Spark Plug Recommendation Changes 18/20/25 and 100/115

Mariner/Mercury 18/20/25

51570

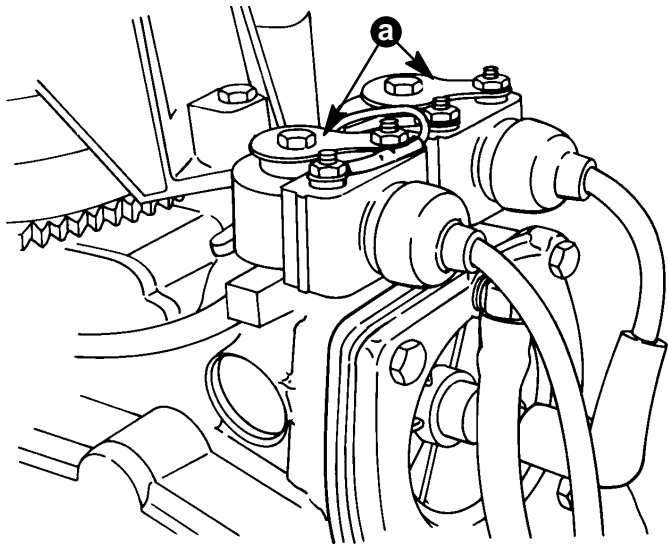
18/20/25 Models - Equipped with a ground plate on the negative (-) ignition coil terminal.

a - Ground Plate - Between negative (-) terminal on ignition coil and coil mounting bolt.

Previous Recommended Spark Plugs	New Recommended Spark Plug
NGK B9HS-10 AC M40FFX Champion L-77JC4	NGK BP8H-N-10 P/N 33-816737--2 Gap 0.040 in. (1.0 mm)
Champion QL-77JC4*	NGK BPZ8H-N-10* P/N 33-816837--2 Gap 0.040 in. (1.0 mm)

51570

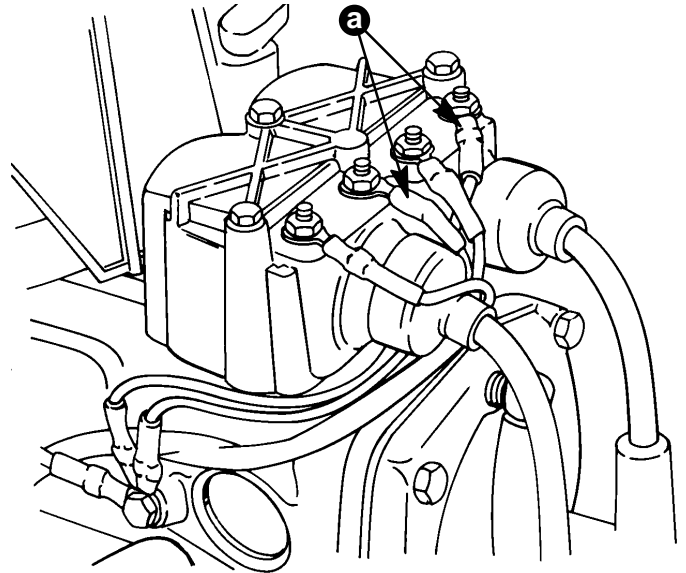
18/20/25 Models - Equipped with a ground wire between negative (-) terminal on ignition coil and powerhead ground.

a - Ground Wire - Between negative (-) terminal on ignition coil and powerhead ground.

Previous Recommended Spark Plugs	New Recommended Spark Plug
NGK BUHW NGK BU8H AC V40FFM Champion L-76V	NGK BP8H-N-10 P/N 33-816737--2 Gap 0.040 in. (1.0 mm)
NGK BUZ8H* Champion QL-78V*	NGK BPZ8H-N-10* P/N 33-816837--2 Gap 0.040 in. (1.0 mm)
